サブウーファー端子の回路 VER2 (シミュレーション・デバッグ済み)

Subwoofer output circuit VER2 (simulated and debugged)

完全バランスアンプのモノラル・サブウーファー出力 VER2 Mono Subwoofer Output (XLR + RCA) VER2

図1 / Figure 1: 完全バランス用 VER2 / Fully balanced VER2

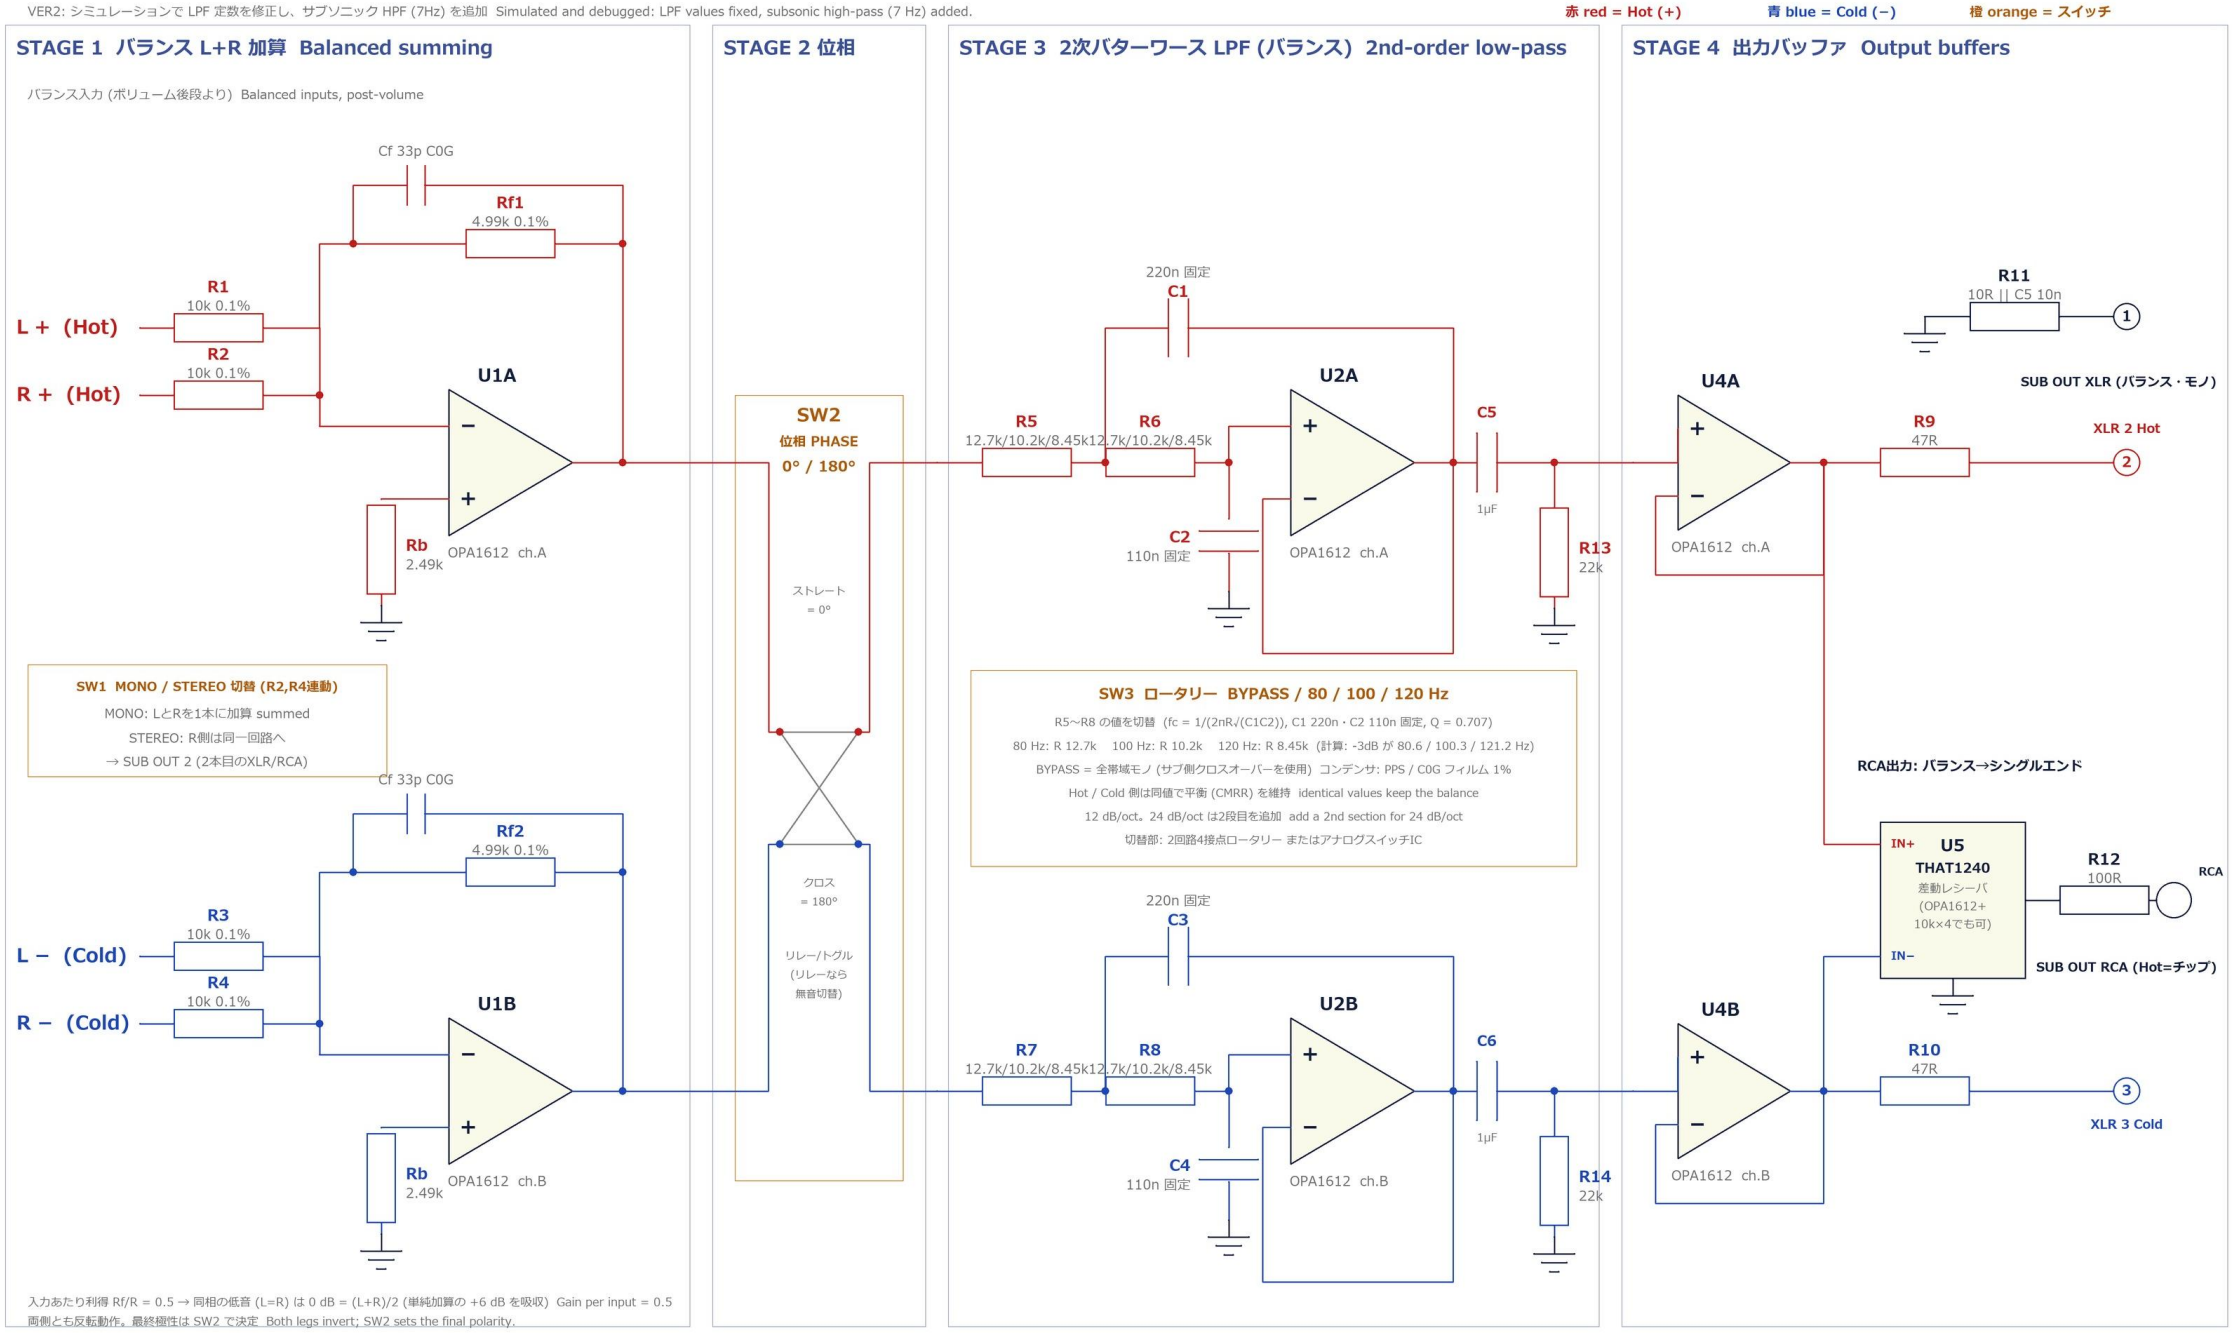
VER2 の変更点

- 上の回路図 (完全バランス用 / アンバランス用) を Python のシミュレーションで検証し、問題を直しました。
- LPF の定数を修正: VER1 の C 値では -3dB が 74.7 / 102.2 / 112.3 Hz でした。C を固定 (C1 220n・C2 110n) して R を 12.7k / 10.2k / 8.45k に切り替えると、80.6 / 100.3 / 121.2 Hz になります (Q = 0.707)。
- サブソニック HPF を追加: VER1 は DC・超低域も通していました。C 1µF + R 22k の1次 HPF (7.2Hz) を LPF と出力バッファの間に入れ、DC を遮断します (20Hz で -0.55dB、5Hz で -4.9dB)。
- 問題なし: L=R の低音は 0dB、各入力の負荷は 10kΩ でプリアウトへの影響は -0.04dB、バイアス整合 (2.497kΩ と Rb 2.49kΩ) でオフセットは無視できます。
- 未実施: 過渡応答・歪み (THD)・ノイズ・実機の位相。実機または SPICE での確認が必要です。

What changed in VER2

- The circuits above (fully balanced and unbalanced) were checked by a Python simulation and the problems were fixed.
- LPF values corrected: with the VER1 capacitor values the -3 dB points were 74.7 / 102.2 / 112.3 Hz. With C fixed (C1 220n, C2 110n) and R switched among 12.7k / 10.2k / 8.45k, they become 80.6 / 100.3 / 121.2 Hz (Q = 0.707).
- Subsonic high-pass added: VER1 passed DC and very low frequencies. A first-order high-pass of 1 uF + 22 kohm (7.2 Hz) between the LPF and the output buffer now blocks DC (-0.55 dB at 20 Hz, -4.9 dB at 5 Hz).
- No problem found: correlated bass (L=R) is 0 dB, each input loads the pre-out with 10 kohm (-0.04 dB), and the bias resistors match (2.497 kohm vs Rb 2.49 kohm), so offset is negligible.
- Not done: transient response, THD, noise and real-hardware phase. Bench or SPICE verification is still required.

図2 / Figure 2: アンバランス用 VER2 / Unbalanced VER2

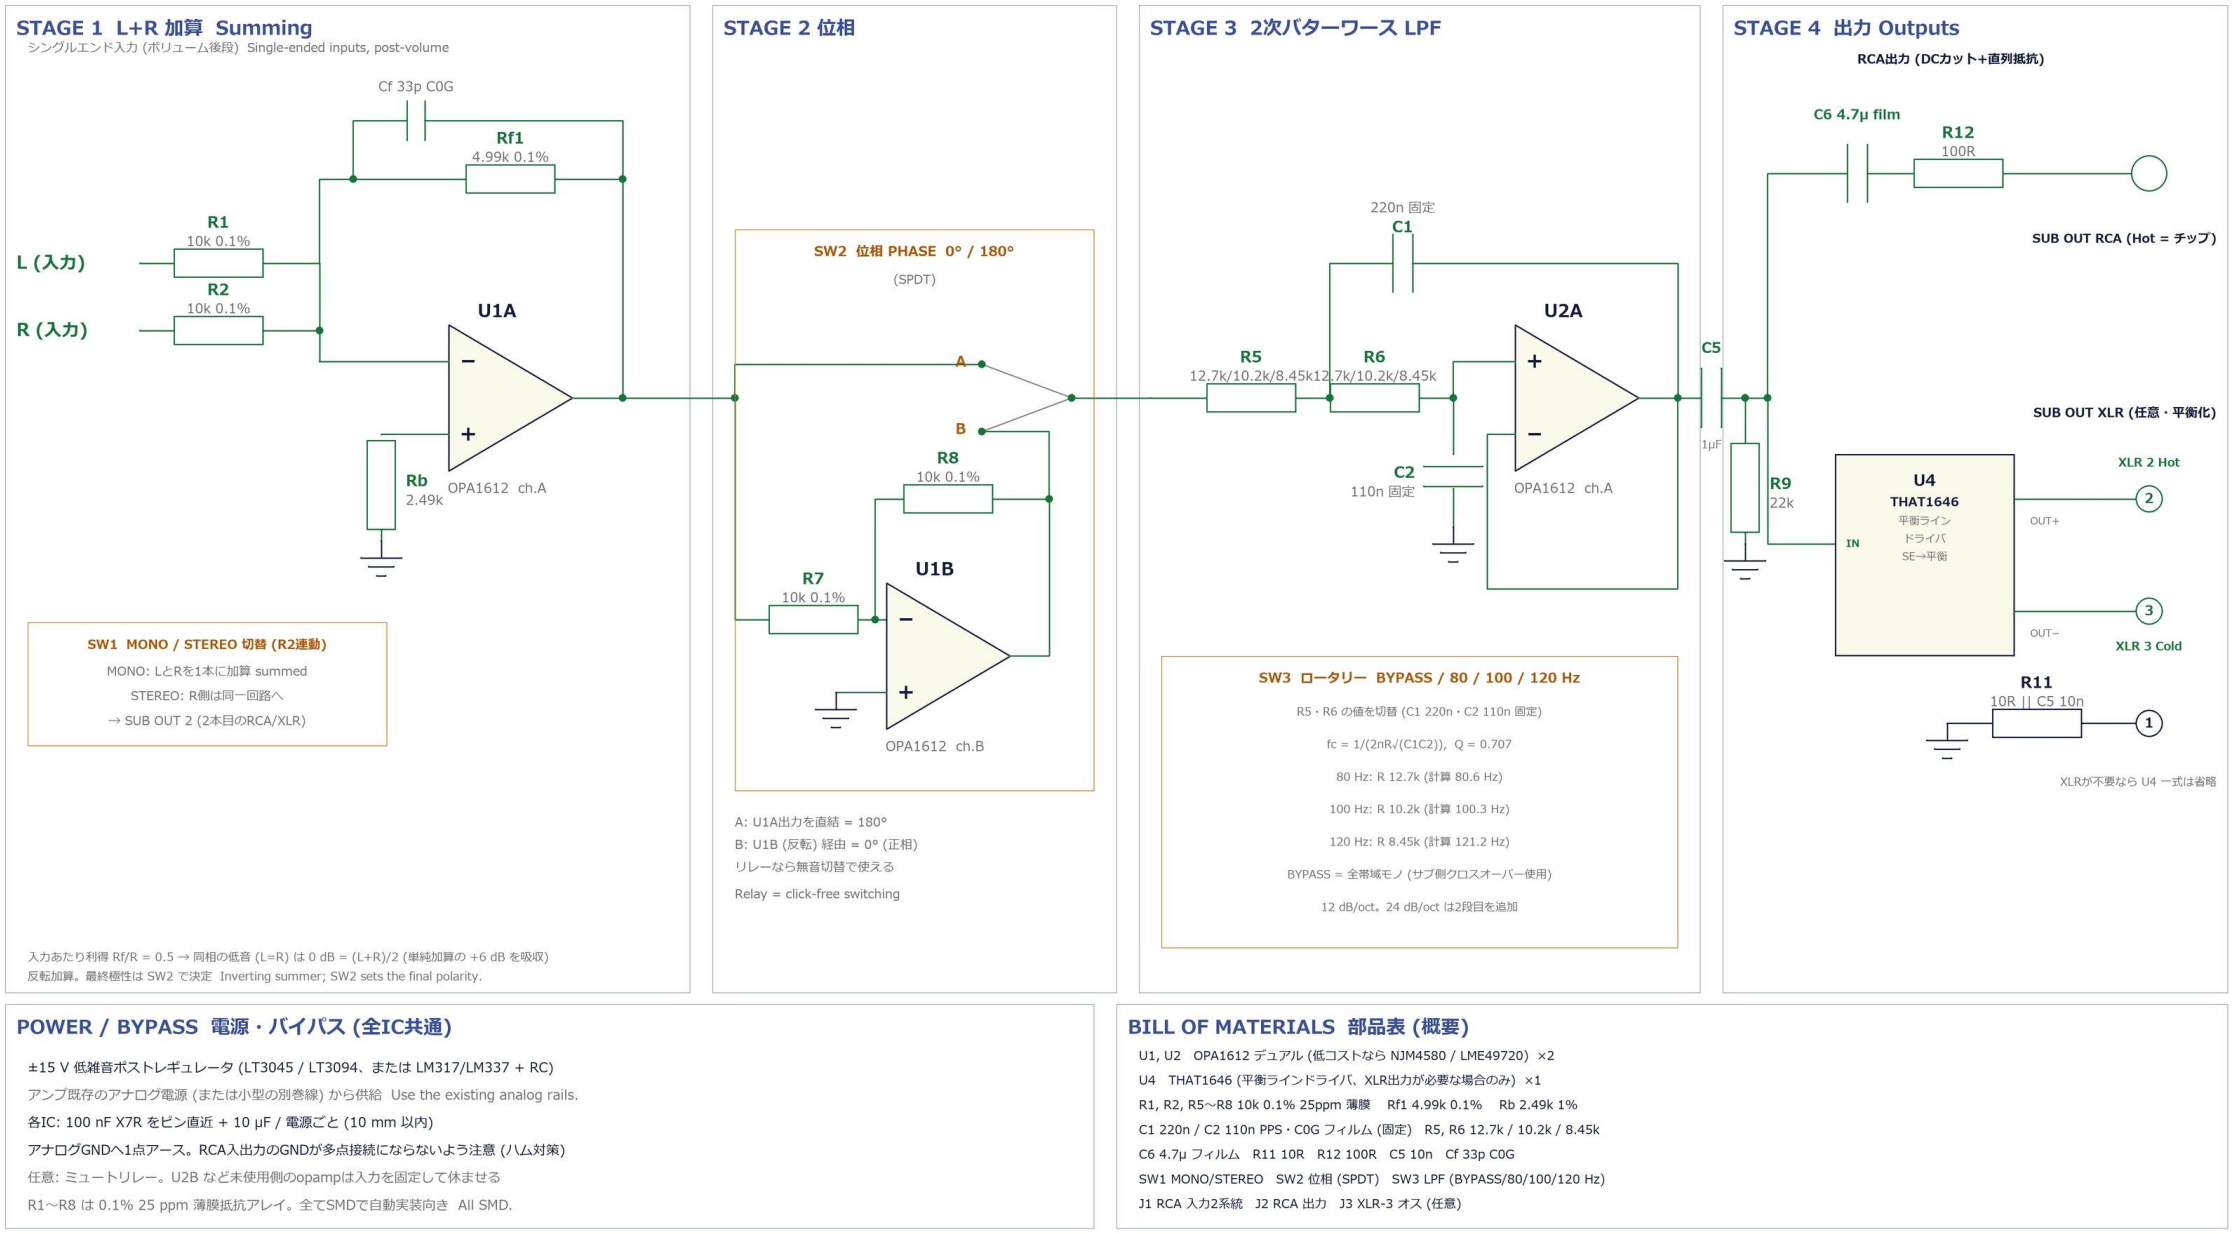
VER2 の変更点

- 上の回路図 (完全バランス用 / アンバランス用) を Python のシミュレーションで検証し、問題を直しました。
- LPF の定数を修正: VER1 の C 値では -3dB が 74.7 / 102.2 / 112.3 Hz でした。C を固定 (C1 220n・C2 110n) して R を 12.7k / 10.2k / 8.45k に切り替えると、80.6 / 100.3 / 121.2 Hz になります (Q = 0.707)。
- サブソニック HPF を追加: VER1 は DC・超低域も通していました。C 1µF + R 22k の1次 HPF (7.2Hz) を LPF と出力バッファの間に入れ、DC を遮断します (20Hz で -0.55dB、5Hz で -4.9dB)。
- 問題なし: L=R の低音は 0dB、各入力の負荷は 10kΩ でプリアウトへの影響は -0.04dB、バイアス整合 (2.497kΩ と Rb 2.49kΩ) でオフセットは無視できます。
- 未実施: 過渡応答・歪み (THD)・ノイズ・実機の位相。実機または SPICE での確認が必要です。

What changed in VER2

- The circuits above (fully balanced and unbalanced) were checked by a Python simulation and the problems were fixed.
- LPF values corrected: with the VER1 capacitor values the -3 dB points were 74.7 / 102.2 / 112.3 Hz. With C fixed (C1 220n, C2 110n) and R switched among 12.7k / 10.2k / 8.45k, they become 80.6 / 100.3 / 121.2 Hz (Q = 0.707).
- Subsonic high-pass added: VER1 passed DC and very low frequencies. A first-order high-pass of 1 uF + 22 kohm (7.2 Hz) between the LPF and the output buffer now blocks DC (-0.55 dB at 20 Hz, -4.9 dB at 5 Hz).
- No problem found: correlated bass (L=R) is 0 dB, each input loads the pre-out with 10 kohm (-0.04 dB), and the bias resistors match (2.497 kohm vs Rb 2.49 kohm), so offset is negligible.
- Not done: transient response, THD, noise and real-hardware phase. Bench or SPICE verification is still required.

図3 / Figure 3: シミュレーション結果 / Simulation results

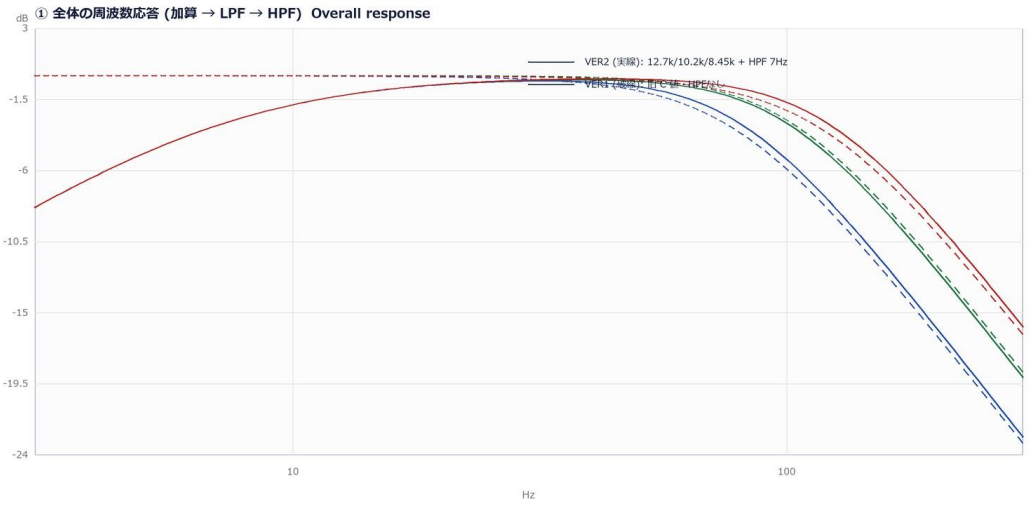
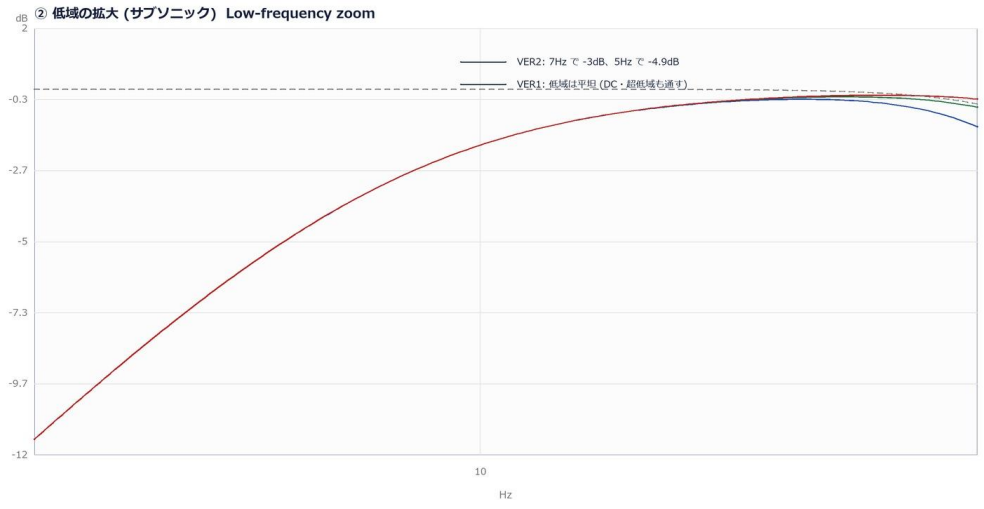
見つかった問題と修正 / 確認結果 (VER2) Problems found, fixes and checks

① LPF: VER1 の C 値では -3dB が 74.7 / 102.2 / 112.3 Hz (目標 80 / 100 / 120) → 抵抗切替 (12.7k / 10.2k / 8.45k) で 80.6 / 100.3 / 121.2 Hz

① LPF: with the VER1 capacitor values the -3 dB points were 74.7 / 102.2 / 112.3 Hz (targets 80 / 100 / 120); switching the resistors (12.7k / 10.2k / 8.45k) gives 80.6 / 100.3 / 121.2 Hz.

② サブソニック: VER1 は DC・超低域も通していた → C 1µF + R 22k の HPF (7.2Hz、1次) を追加。20Hz で -0.55dB、10Hz で -1.8dB、5Hz で -4.9dB (DC を遮断)

② Subsonic: VER1 passed DC and very low frequencies; a 1 uF + 22 kohm high-pass (7.2 Hz, first order) was added: -0.55 dB at 20 Hz, -1.8 dB at 10 Hz, -4.9 dB at 5 Hz, and DC is blocked.

③ 加算: L=R の低音は 0dB (-0.02dB)。L と R が逆相だと打ち消す。Rf/Cf の極 966kHz、帰還帯域は GBW 制限で ≈ 20MHz。バイアス整合 (2.497kΩ vs Rb 2.49kΩ) でオフセットは無視できる

③ Summer: correlated bass (L=R) is 0 dB (-0.02 dB); anti-phase bass cancels. The Rf/Cf pole is 966 kHz and the loop bandwidth is about 20 MHz (GBW limit). The bias resistor matches (2.497 kohm vs Rb 2.49 kohm), so offset is negligible.

④ 負荷: 各入力は 10kΩ。プリアウト (出力 ≈ 47Ω) への影響は -0.04dB。出力 47Ω + ケーブル 10nF の極は 339kHz で影響なし

④ Loading: each input is 10 kohm; the effect on a 47 ohm pre-out is -0.04 dB. The 47 ohm plus 10 nF cable pole is at 339 kHz and has no effect.
